Medina County Sanitary Engineers
C.H. 42 Grafton Road Water Main Replacement Project 2022
WR-500/5-1.3

ADDENDUM 2

November 1, 2022

PAVEMENT AND ZONE OF INFLUENCE DETAILS

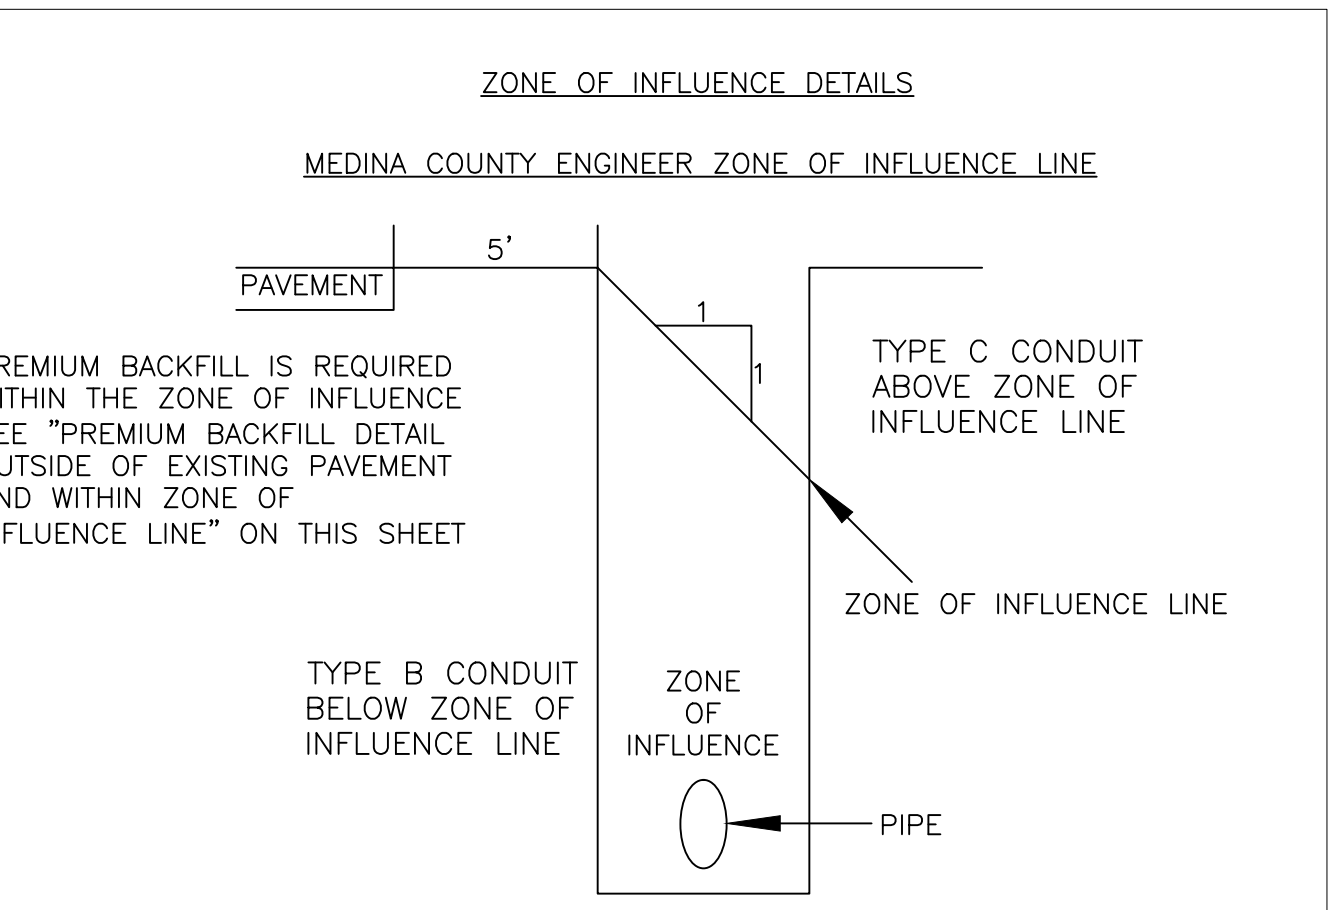
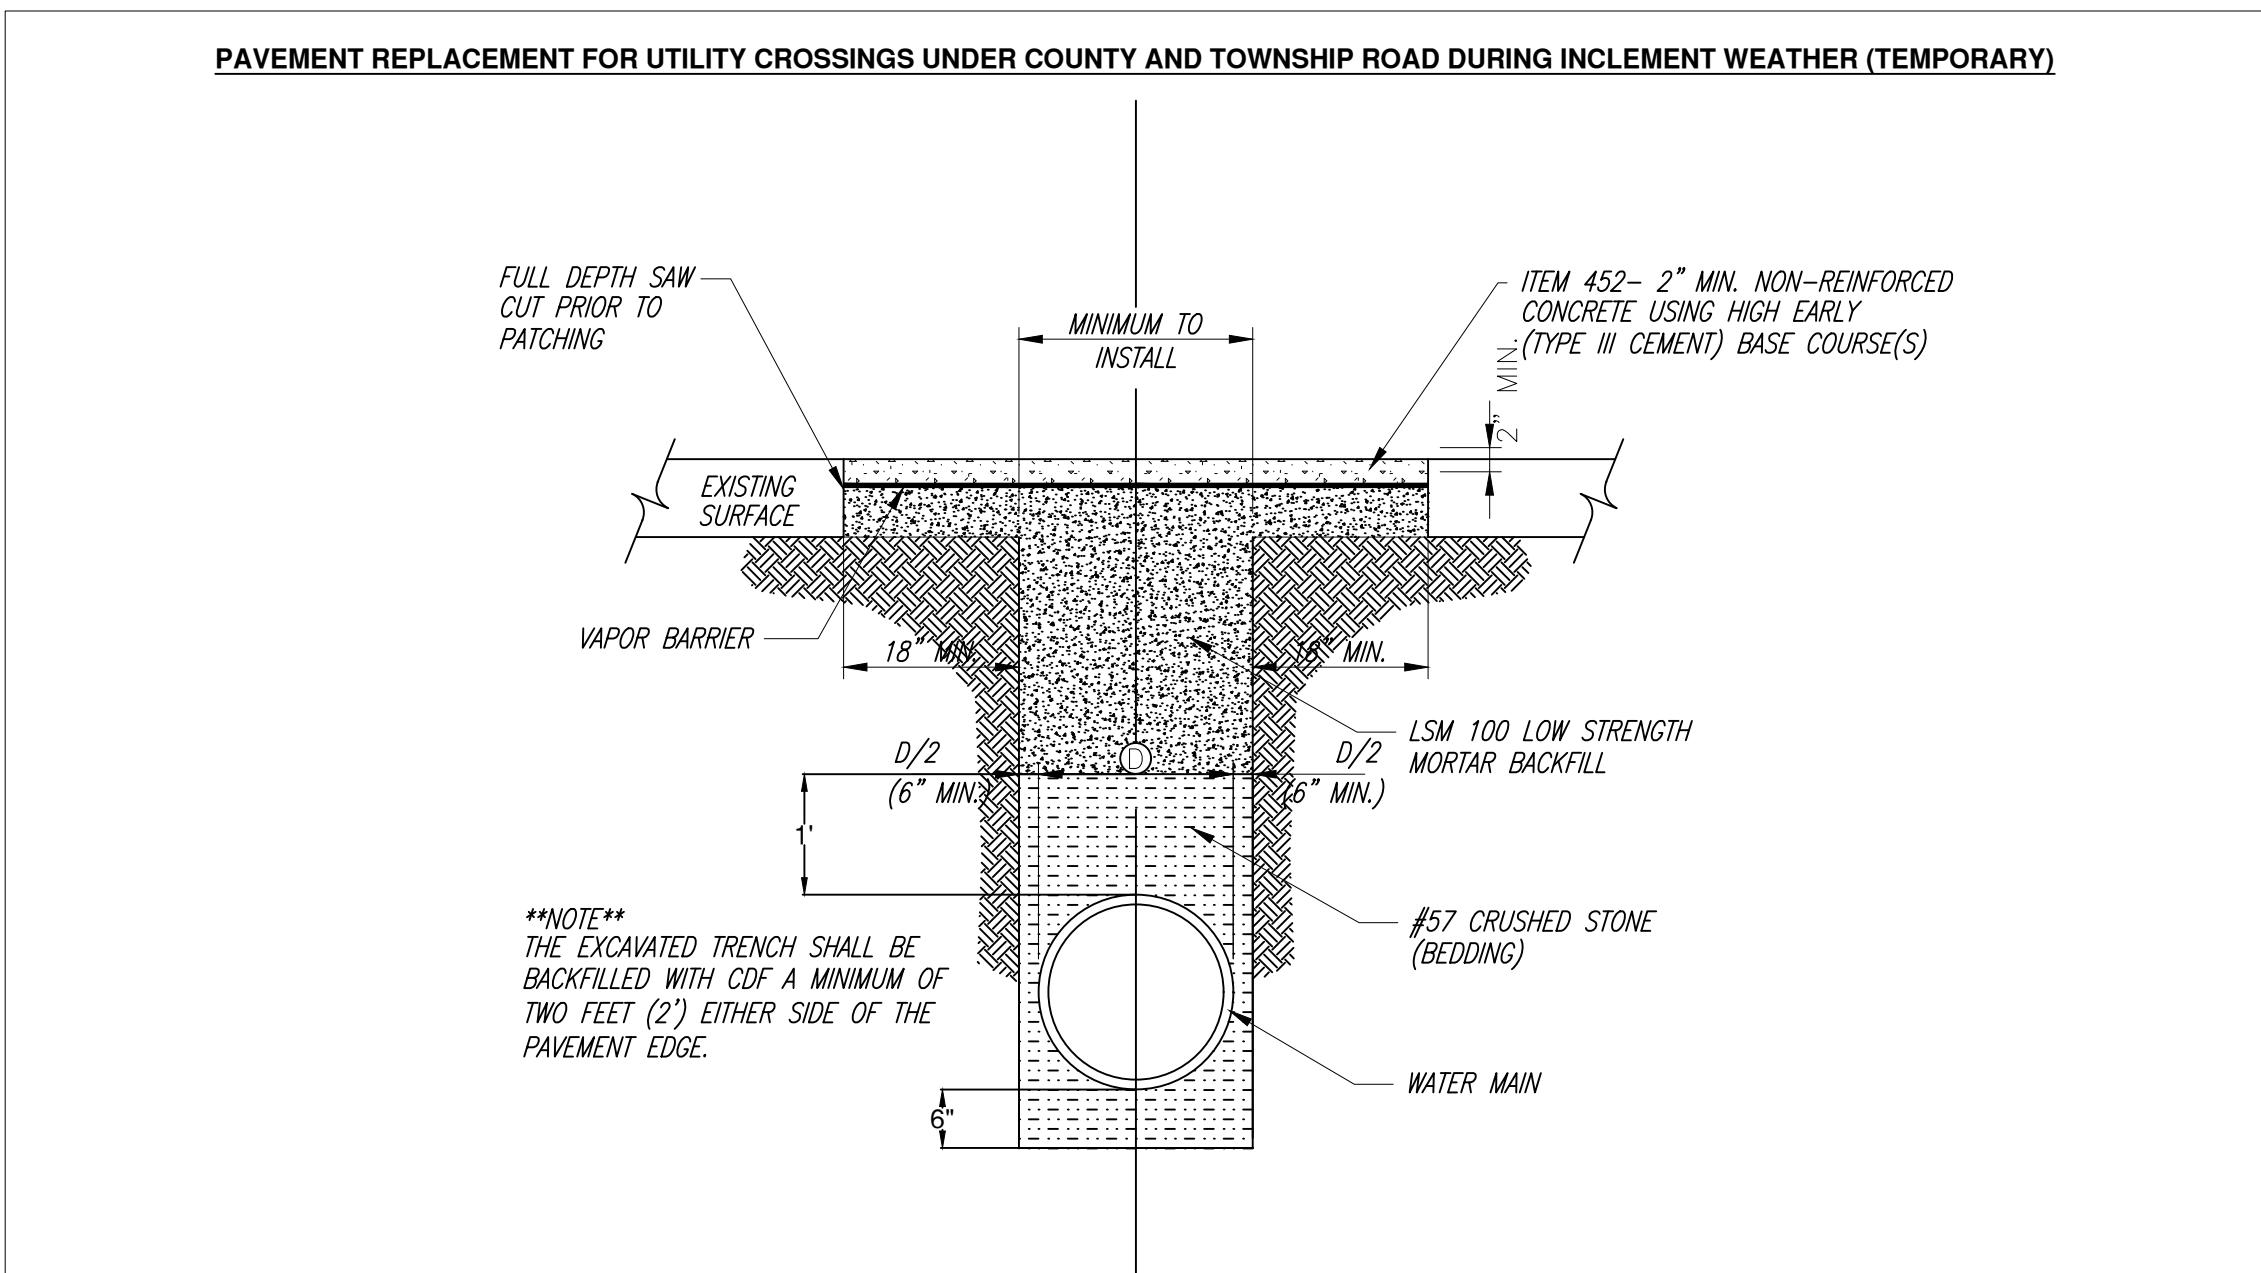
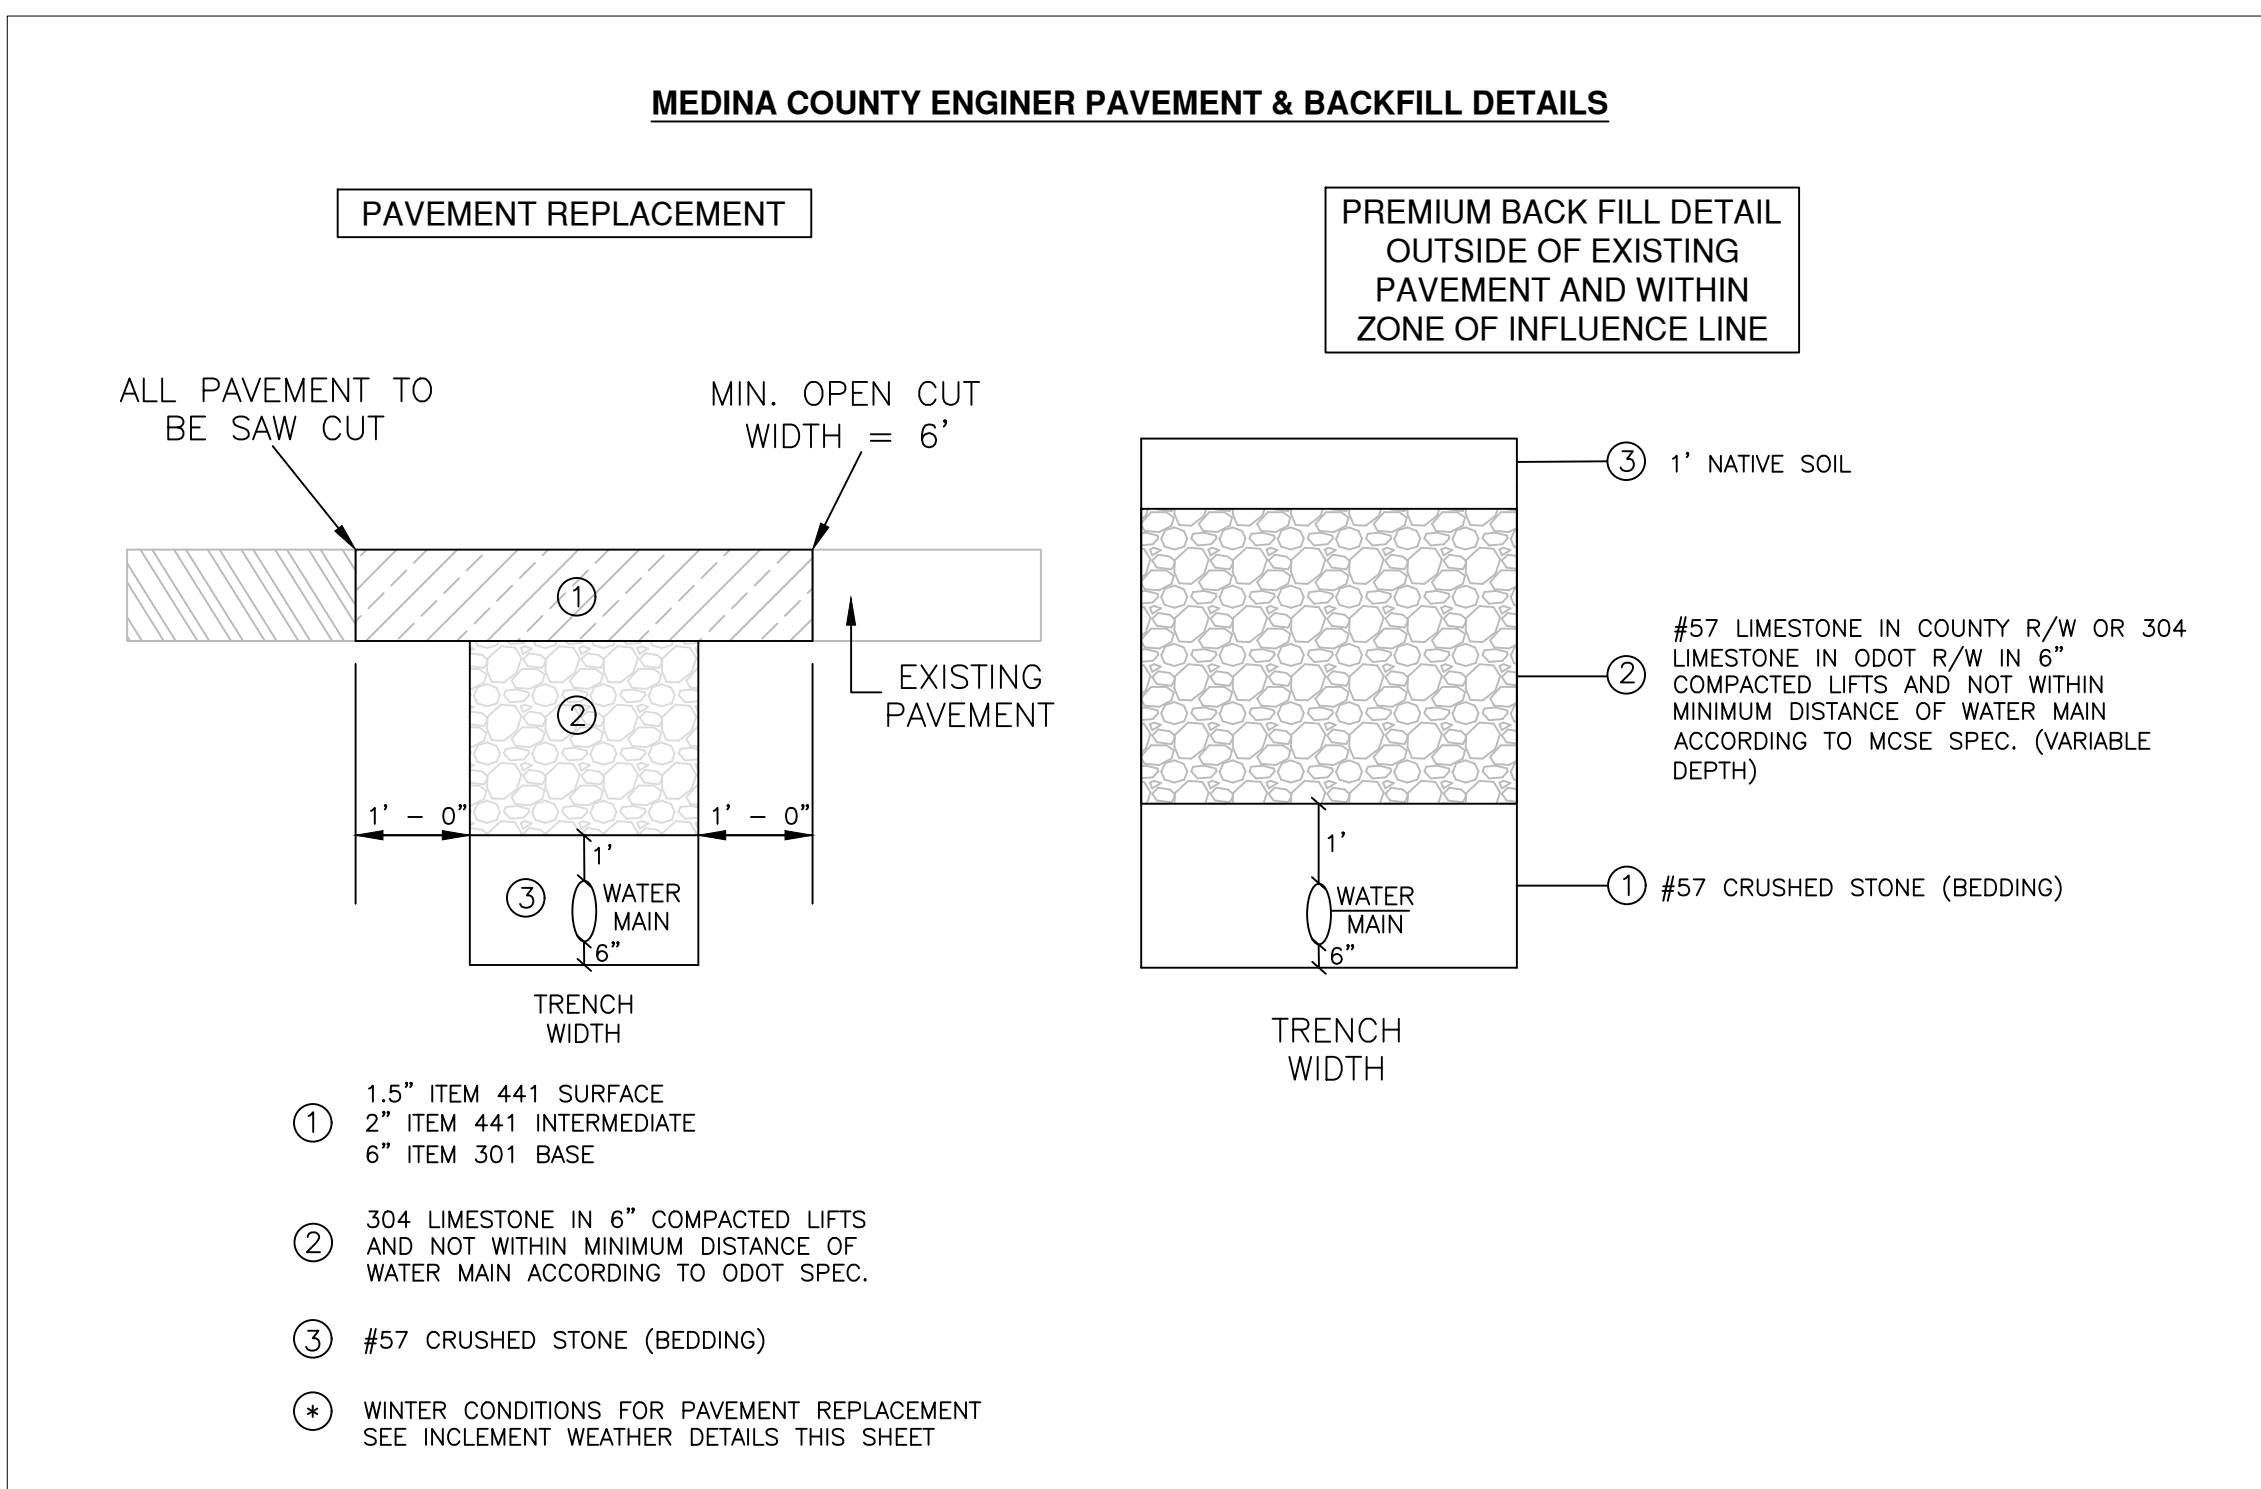
There is no fee for the MCE highway permit. However, there is a change for the driveway and ditch enclosure permit fees. Sheet 2 (General Notes) has been updated with this information. Please see attached.

Question #8 – Is premium backfill required at a 1:1 off e/p or 5' and then a 1:1?

Question #10 – Does premium only need to be brought up to 1:1 or does it have to be brought to within 1 ft of the surface?

- If drive pipe is to be disturbed or conduit placed between EOP & drive culvert, a driveway permit is to be obtained by the Contractor from MCE and Contractor is responsible for any permit fees. Driveway permit valid for one (1) year will cost \$100.00. Driveway permit valid for six (6) months will cost \$75.00. Driveway permit valid for three (3) months will cost \$50.00.

- If ditch enclosure is to be disturbed, a ditch enclosure permit is to be obtained by the Contractor from MCE and Contractor is responsible for permit fee. Cost for Ditch Enclosure permit is \$100.00 and is valid for one (1) year.

- Premium backfill on Grafton Road (CH-42) and Marks Road (CH-22) shall be 304 used under pavement and #57 Limestone shall be used outside of pavement per details on this sheet. Backfill should have 95% compaction. The use of Control Density Fill (CDF), if requested for use by the Contractor, is acceptable.
